Report to Planning and Environment Committee

Subject: Richmond Hyland Inc. c/o Paul Kitson - Westdell
Development Corporation
1725-1737 Richmond Street
File Number: Z-9741, Ward 9
Public Participation Meeting

Date: July 16, 2024

Figure 6 – Overall Site Plan Concept

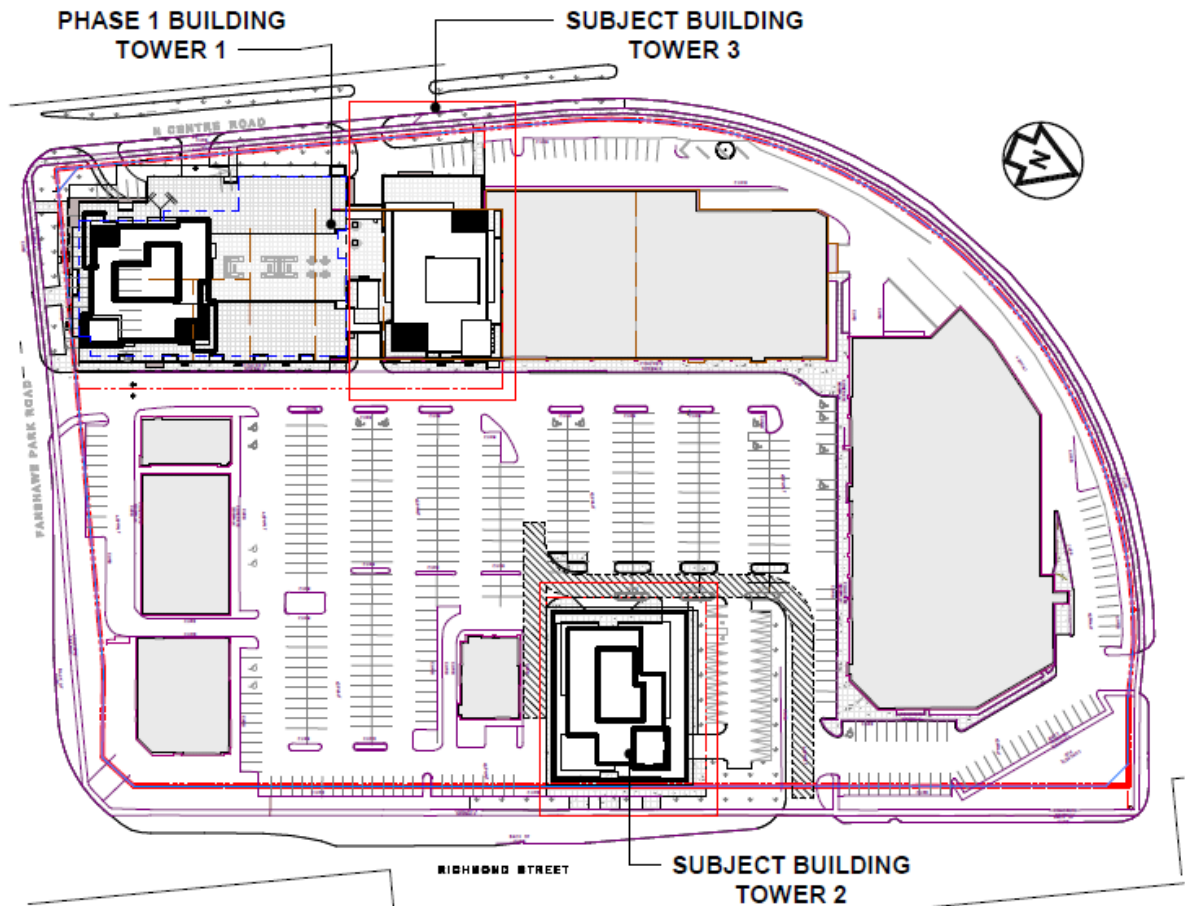
- i) As the number of residential units exceeds 24, a lay-by is required to be provided on-site for Tower 2. At the time of Site Plan Consultation, the applicant is to demonstrate how this can be provided on site for Tower 3, separate from the one provided for Tower;

- ii) Explore options to provide a common outdoor amenity space for Tower 2 that is suitable in size with features to accommodate the anticipated population of this tower. As the proposal is currently overparked, consider redesigning the surface parking area to replace parking spaces with amenity space, while still maintaining access to the structured parking;

- iii) The proposed parking area to the north of Tower 2 does not provide for safe pedestrian crossings to the building. Update the site plan accordingly to provide for safe pedestrian connections. The current plan requires pedestrians to cross over the underground parking ramps on either side;

Figure 12 – Overall Master Plan showing possible development and future phases over the long term

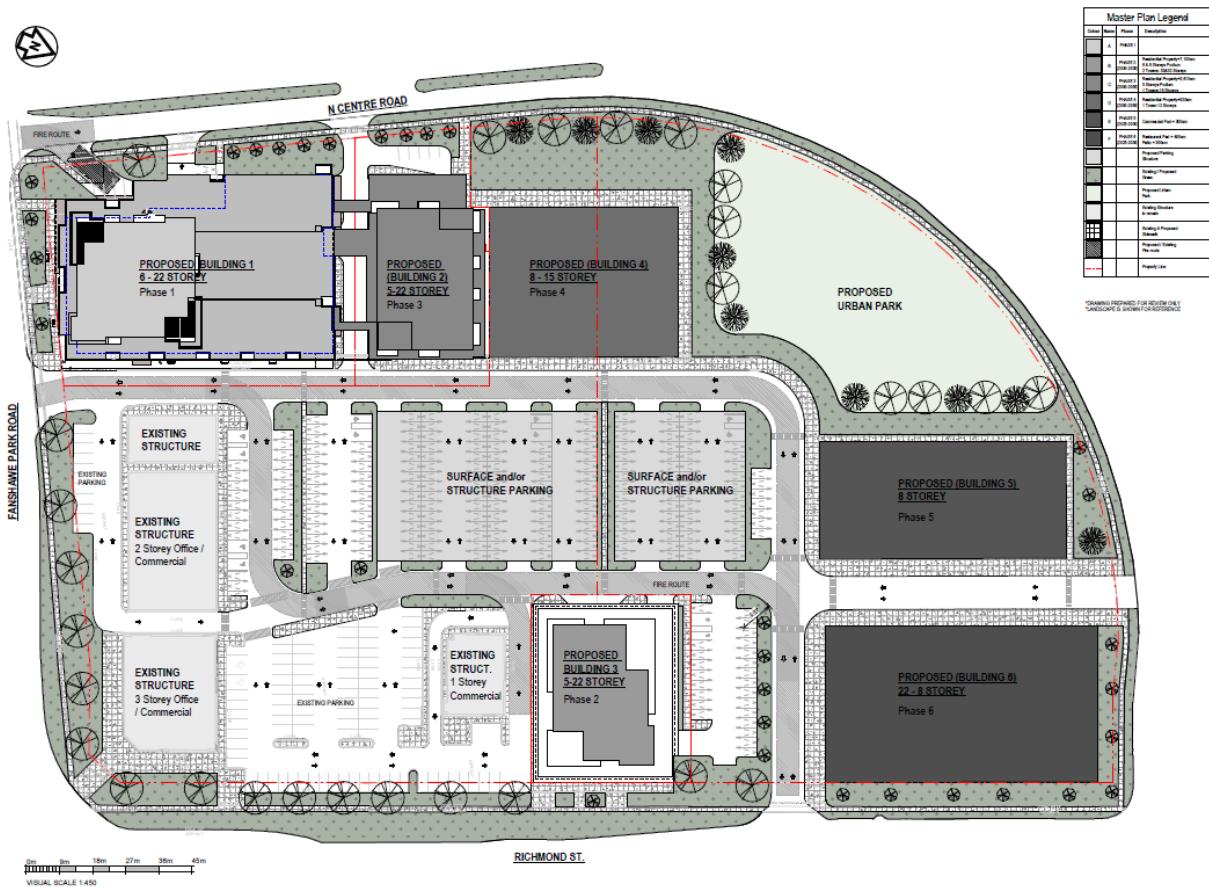
A future parkland block has been proposed for the northwest corner of the site where the current Michaels store is located as shown on Figure 12.

The location for the park proposed in the conceptual master plan is within an existing, tenanted commercial building and is therefore difficult to obtain at this time. During the review of Tower 1, the City accepted cash-in-lieu at the time of Site Plan Approval as an acceptable form of parkland dedication. However, a land dedication in the amount of 0.5 hectares is required through the development of Phases 2 and 3, in accordance with Policy 3.7 of the Masonville Secondary Plan, and is to be secured through the Site Plan Approval process.

Tower 2 Site Plan Concept

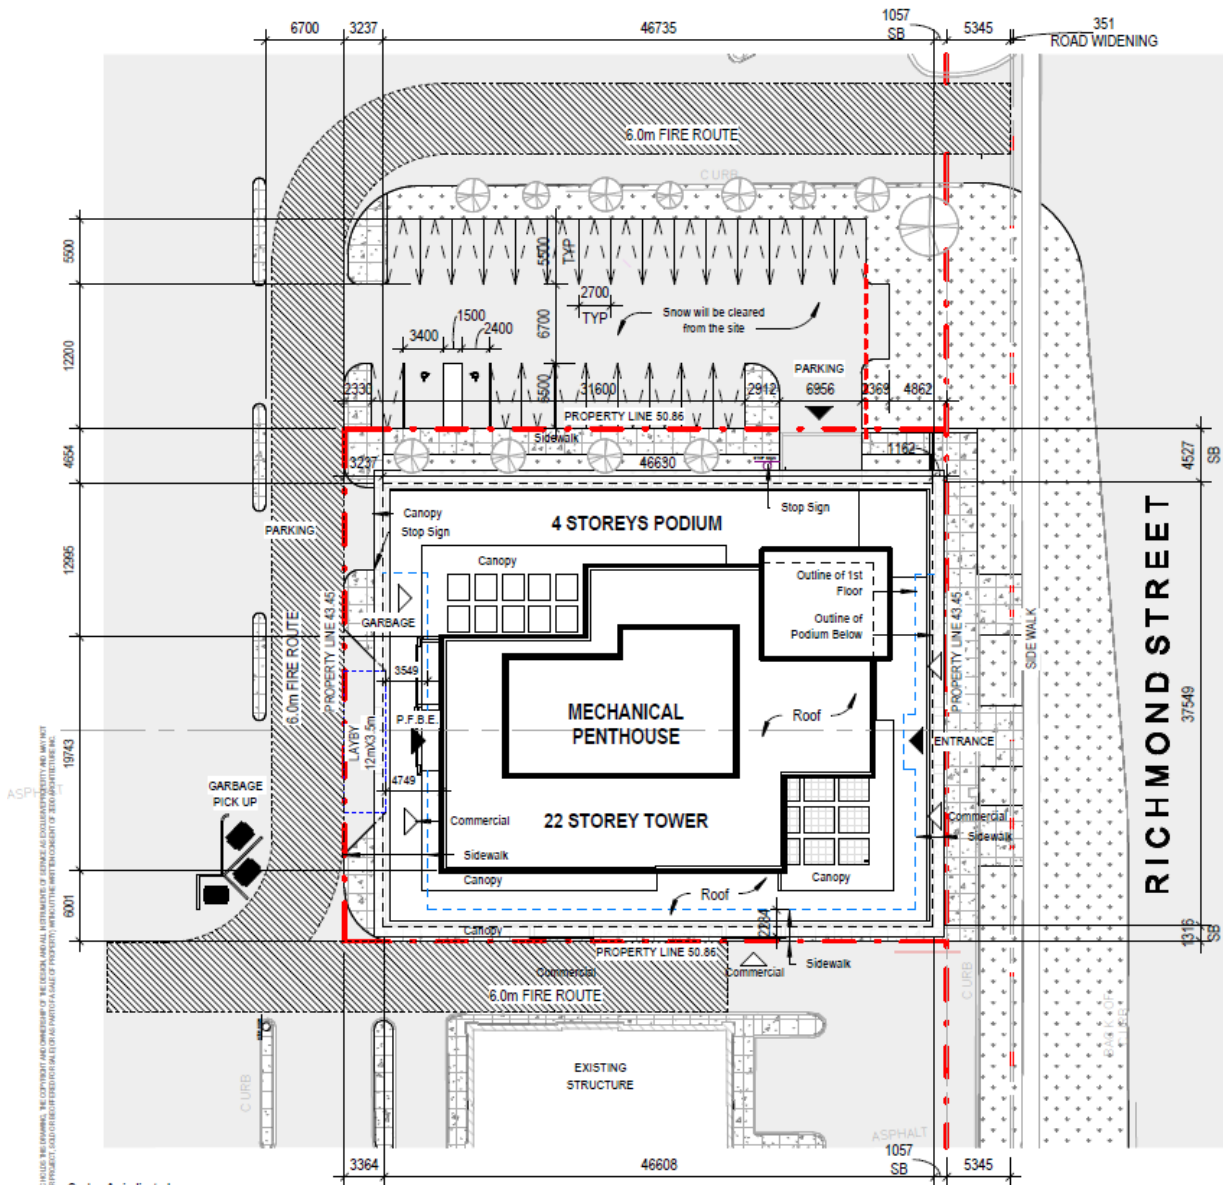
- **TOWER 2:**
- Clarify whether the shown fire route, underground parking access driveway, and surface parking area will be within the same Zone boundary as this Tower. If it will not, then update the parking counts to remove these parking spaces (including the accessible parking spaces). As well, if these lands are intended to be severed off, Staff encourage the applicant to pursue full Site Plan Approval first to ensure that a master Development Agreement is registered on title to avail themselves of Section 4.16.4 of the Zoning By-law and to avoid disconnecting any of these essential site features from this Tower.

- **TOWER 2:**
- At the time of a Site Plan Application (and through the Zoning By-law Amendment process), provide details on the underground and upper parking level plans including parking stall dimensions and a separate plan for each floor of parking.

Tower 3 East Elevation

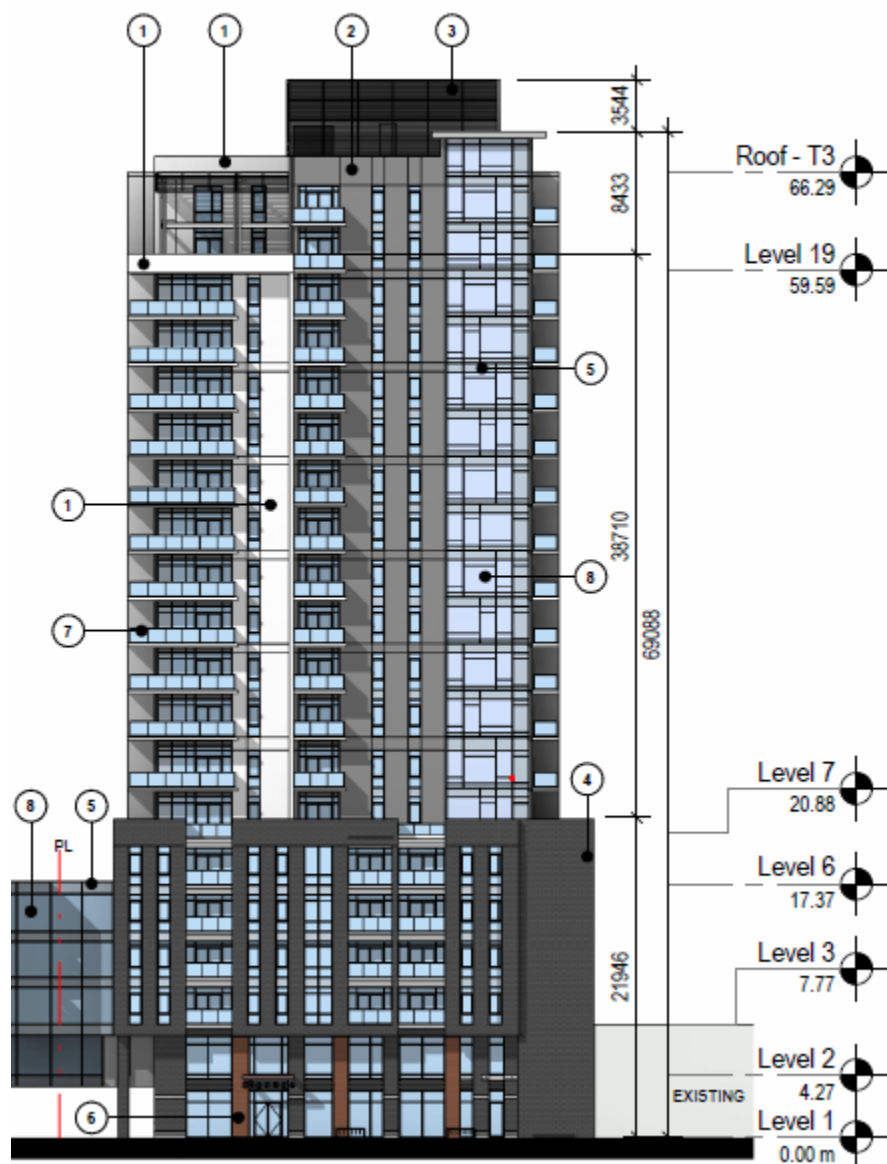
- **TOWER 3:**
- There is no dedicated space for paratransit vehicles or general loading/unloading. Explore options to provide this dedicated space and ensure that it complies with the Site Plan Control By-law standards in terms of size, location, and overhead weather protection.

- Provide a north-south pedestrian connection internal to the site from the proposed to the existing commercial buildings to the south.
- **TOWER 3:**
- The proposed waste collection strategy may prove problematic as municipal vehicles can only load from the front of the truck and a dedicated loading space has not been provided for these vehicles.
